Lockdown Assembly, Front Molding & Button Plug (New Style)

How to identify the differences between the old style (previous page) and new style (this page) :

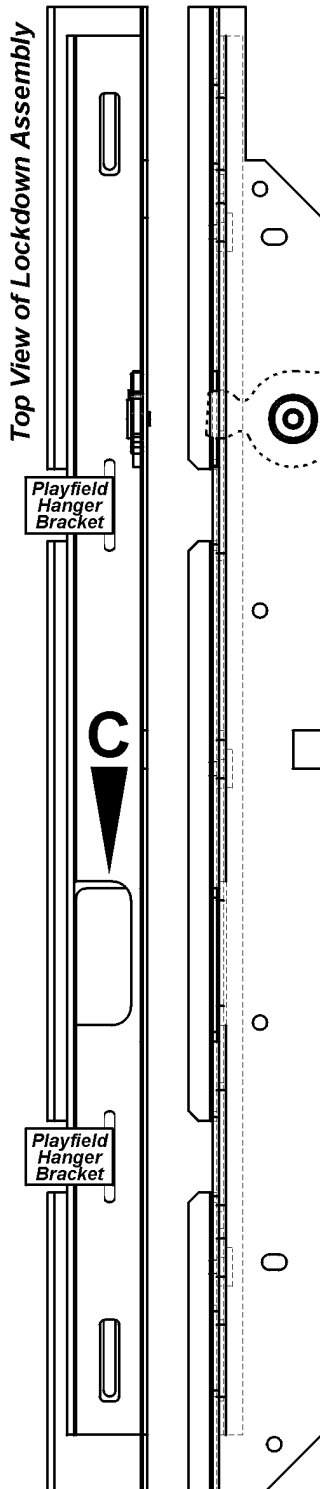
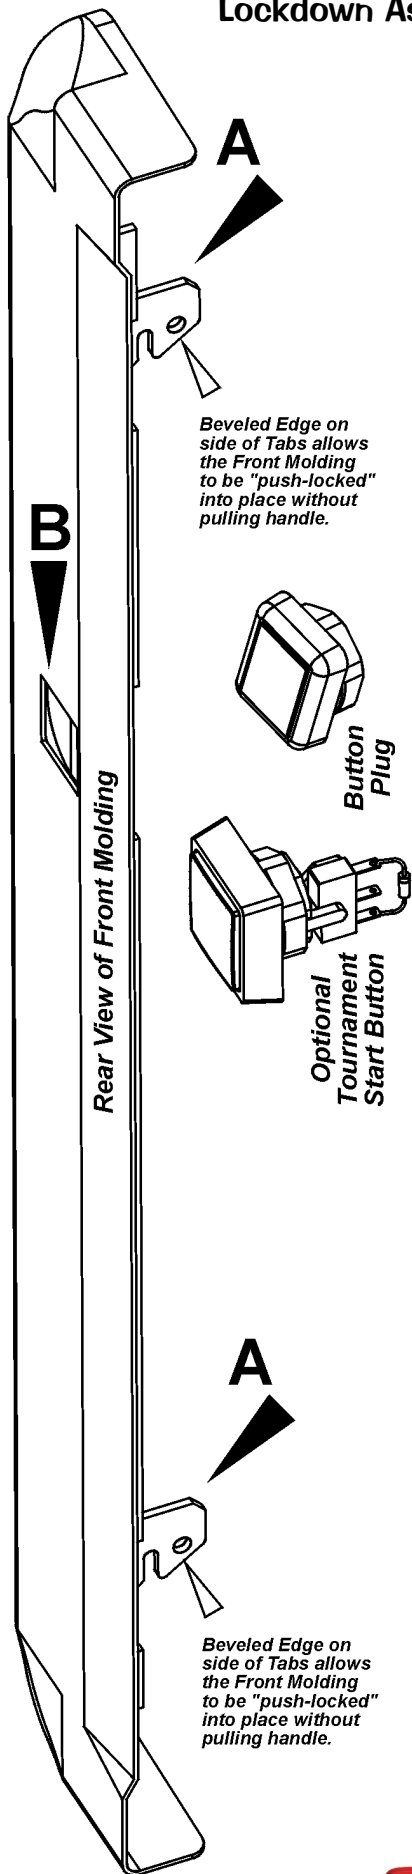
PART NUMBER	DESCRIPTION	IDENTIFYING POINTS
500-6882-00-00 (Black)	Front Molding ‡ (with square hole; new style)	A = 2 Tabs located at the left and right sides. B = Button Hole Access is square.

500-6881-00	Lockdown Assembly (new style)	C = Access Hole no longer has an open end cut-out.
500-6883-00	Button Hole Plug ‡‡	Square Top
500-6884-00	ToPS™ Start Button ‡‡	Fits Square Button Hole

Note: The Front Molding will only work with this Lockdown Assembly, the Button Plug & ToPS™ Start Button will only work with this Front Molding.

‡ Will only fit on 500-6881-00 Lockdown Assembly

‡‡ Will only fit in 500-6882-style Front Molding
